Ferrari North America

Technical Information

Date: January 2019
Bulletin #: 2554
Campaign #:
Supersedes: 2446
Section: 7

Model Type: 458 Italia/Spider/Speciale/Speciale A, California, California T, FF, F12Berlinetta, F12tdf, 812 Superfast, Portofino, 488 GTB/Spider, GTC4Lusso/ LussoT
Subject: New passenger airbag module and brackets

Fig. 1

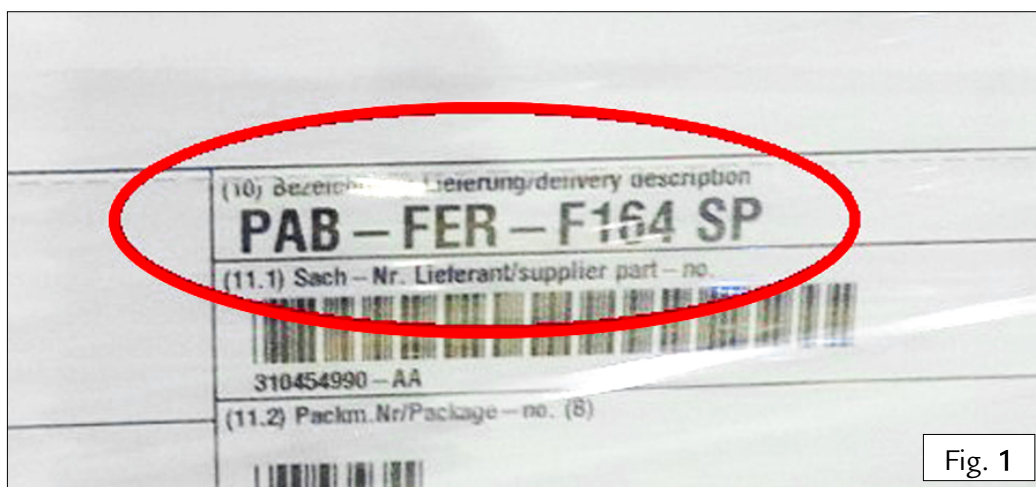
Please note that installation of the new passenger airbag module **Part No. 89207500** requires the use of special brackets to fasten it to the dashboard.

The new component is marked with a specific label bearing the phrase "PAB-FER-F164 SP" on the packaging, as seen in **Fig. 1**.
